# MIAMI BEACH

### Staff Report & Recommendation

### Design Review Board

SUBJECT: **DRB20-0505**  
**666 71<sup>st</sup> Street, 6973 Indian Creek Drive, and 6980-6994 Carlyle Avenue**

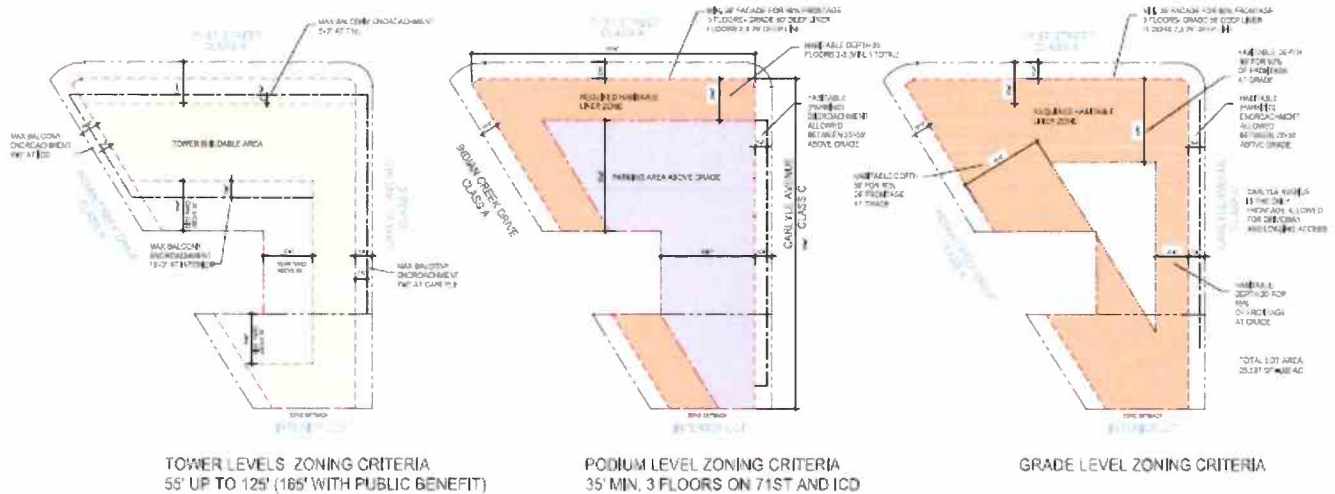
As illustrated above, it is extremely challenging, if not impossible, to address all of the habitable liner requirements of Class A street frontages with regard to height, depth and levels, as well as design a functional parking system on a triangular lot. The TCC requires screening parking and providing habitable active uses at a height and intensity commensurate with the corridor they are adjacent to. Due to the triangular shape and dimensions of the site assemblage, it appears that it is not geometrically possible to provide the parking sought by the applicant (but not all required), while meeting the dimension and spatial requirements for the parking stalls, drive aisle widths, turn radiuses and back up dimensions necessary to design a safe parking system and comport with the Class A street requirements pertaining to the liner uses. Staff would note that the required habitable space with a depth of 50'-0" is provided along the 71<sup>st</sup> Street ground floor, as well as portions of the ground level along Indian Creek Drive, which is essential to the pedestrian experience.

In this proposal, the design substitutes the habitable liner used to screen the parking by providing architecturally relevant and contextually appropriate façade screening systems and providing residential units on 71<sup>st</sup> Street and partially on Indian Creek Drive and Carlyle Avenue on levels four to twelve. Staff has worked closely with the applicant in prioritizing the street level activation of Indian Creek Drive and 71<sup>st</sup> Street as the significant retail opportunities for this signature gateway site. The design endeavors to meet the intent of the code to activate the street and provide visual screening of the parking through the use of enhanced architectural screening. Staff does suggest continuing refinement of the parking screening, as the design is of paramount importance at this gateway site and considering the screening will be at a much lower elevation than typical and thus more visible and subject to more severe scrutiny from pedestrians and motorists. As such, staff recommends

approval of variances #1-8 associated with the habitable depth at the second and third levels along both Class A streets.

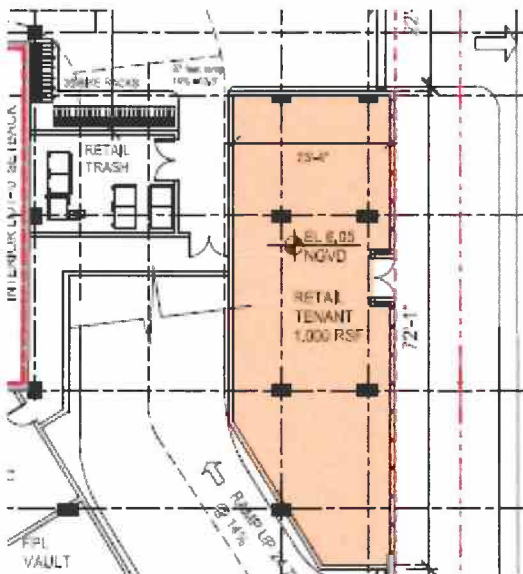
The ground floor retail space must contain habitable space along 85% of the building façade with a minimum depth of 20'-0" for Class C frontages. Based on the length of the property facing Carlyle Avenue, a linear requirement of 131'-4" of habitable space is required with 20'-0" of habitable depth. The design provides 140'-0" of linear along this street. The project contains approximately 198'-0" of linear frontage with the two driveways subtracted brings the amount to 154'-0" for zoning calculation purposes. However, the depth of 20'-0" is not consistent for the entire length. Approximately 22'-0" of frontage adjacent to the driveway does not provide the required 20'-0" in depth, as the driveway turns into its approach of the ramp. Staff finds that there are practical difficulties inherent to the irregular shape of the property that result in the variance requested. In reviewing the ground floor site plan comprehensively, the 71<sup>st</sup> Street frontage contains a continuous and uninterrupted commercial space for the entirety of the 165'-2" of Class A frontage and comports with the transparency requirement for visual display into the space. Working closely with staff through multiple meetings, it was agreed upon that the priority of compliance with the TC-C stringent street frontage regulations would be the two Class A streets. However, the applicant did make a concerted effort to activate and design Carlyle as closely as possible to the ground floor regulations.

reduced habitable depth along Carlyle Avenue.

Detail of site plan loading bay area accessed off of Carlyle Avenue

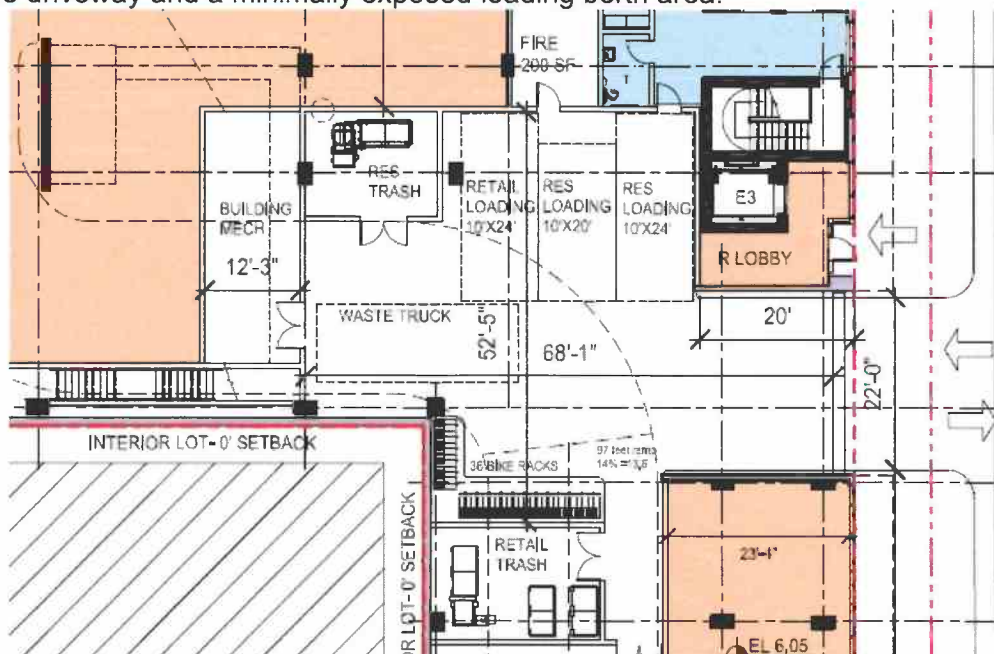
15. A variance to allow loading area / surface parking to be not entirely screened from public right of ways and pedestrian path along Carlyle Avenue (Class C).

Detail of Indian Creek Drive elevation

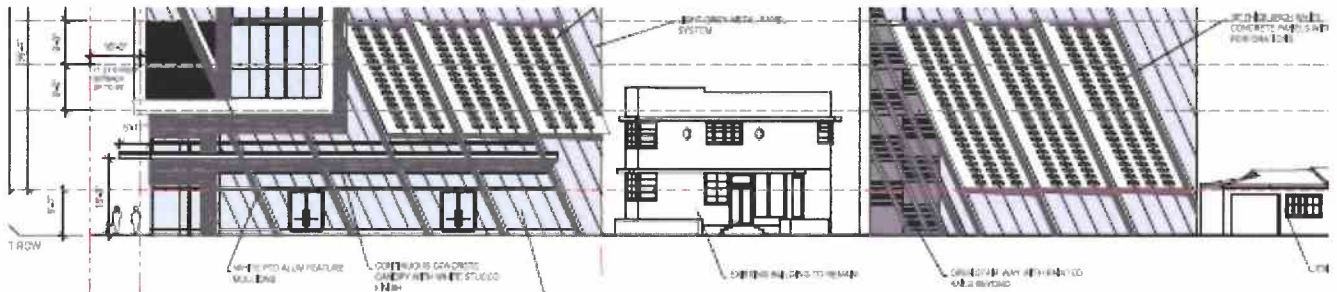
As noted above, in this very limited instance, staff supports the placement of the FPL / fire protection spaces on the southern portion of the site along Indian Creek Drive (variance #10) because it allows for maximizing the remaining street frontage pedestrian activation. However, has very serious concerns with the lack of a shade element along this portion of the block. It is already a great compromise to the promotion of an active urban core by not providing active uses along this section of a Class A street frontage. By not providing pedestrians a comfortable setting along the clear pedestrian path, however, is fully contrary to the overall intent of the TCC district. In this regard, a continuous shade element is critical to not only providing both shelter from the rain and sun, but also to further harmonize the entire project.

However, architectural shading element guidelines have also been established by street frontage class, which require the new buildings to provide additional comfort and shade to the pedestrians to compliment an active streetscape for an enjoyable and comfortable, walkable neighborhood. Staff finds that there are no practical difficulties or hardships associated with this variance, since this is a design driven element and there is plenty of opportunity to architecturally express an eyebrow or similar shade element. As such, staff **STRONGLY** recommends denial of variance #16, and further recommends that the canopy/shade structure provided shall extend along the south side of the property line.

3. The architect shall revise the ground floor site plan to comply with providing a continuous shade structure over the pedestrian path along the portions of the facades of the entirety of the development along of Indian Creek Drive.
